KPC4 OUTPUT
LEVEL MOD

WARREN VK3XSW
31.7.2

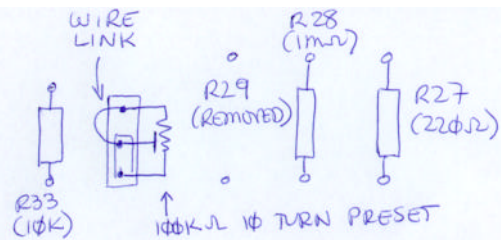
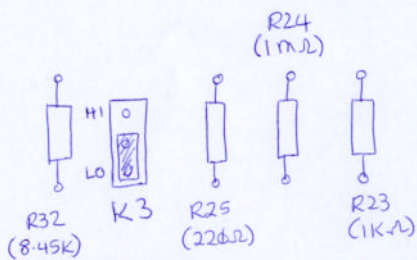
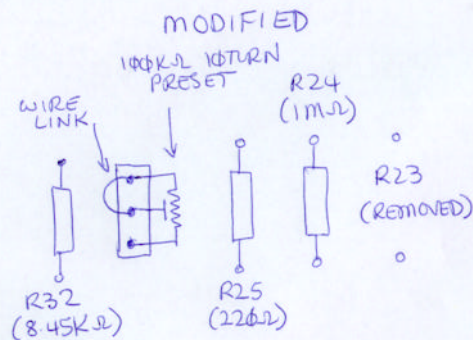
MODIFICATION

- REMOVE JUMPER BLOCKS K3 AND K4
- REMOVE RESISTORS R23 AND R29 (1KΩ)
- INSERT 100KΩ 10TURN PRESET AS SHOWN
- * R25 = R27 SET MINIMUM OUTPUT LEVEL (10mV)

MIN - 10mV

MAX - 1.2V

VARIABLE BETWEEN 10mV AND 1.2V

K3/K4 LO - 10mV
HI - 50mV
OFF - 1.7V
